## PRODUCT / PROCESS CHANGE NOTIFICATION

1.1 Company	 STMicroelectronics International N.V
1.2 PCN No.	MDG/24/14405
1.3 Title of PCN	ST Calamba (Philippines) UFQFPN 7x7 48L package line additional source for STM32G05x/G06x, STM32L45x/L46x and STM32G0Bx/G0Cx listed products
1.4 Product Category	STM32G05x/G06x, STM32L45x/L46x and STM32G0Bx/G0Cx
1.5 Issue date	2024-05-29

**PRODUCT/PROCESS  
CHANGE NOTIFICATION  
PCN14405**  
– Additional information

**ST Calamba (Philippines) UFQFPN 7x7 48L package line  
additional source for STM32G05x/G06x, STM32L45x/L46x and  
STM32G0Bx/G0Cx listed products.**

### How can the change be seen?

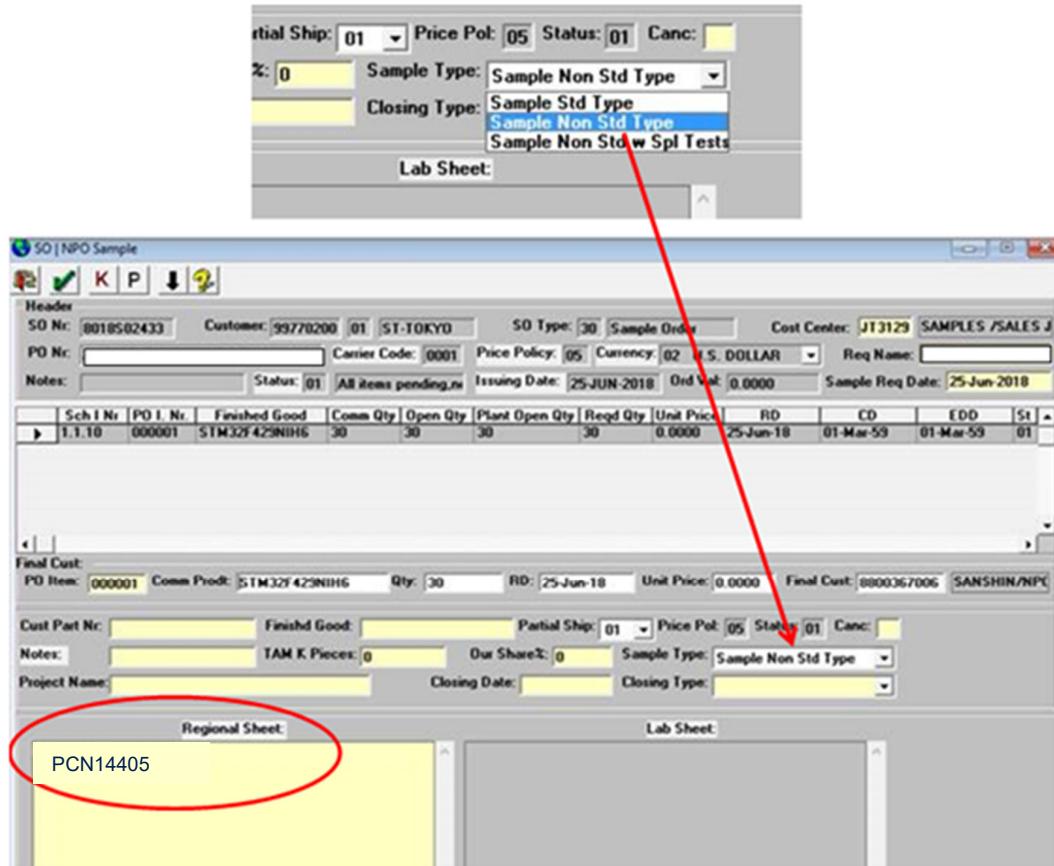
Marking	Existing	Added Back-End Site
UFQFPN 7x7 48L		
PP code	<b>AA:</b> ASE KaoHsiung (Philippines) <b>GQ:</b> Stats ChipPAC JSCC Jiangyin China	<b>78:</b> ST Calamba (Philippines)

**Y WW code** indicates Year Week (manufacturing date)

**PP code** indicates assembly traceability plant code.
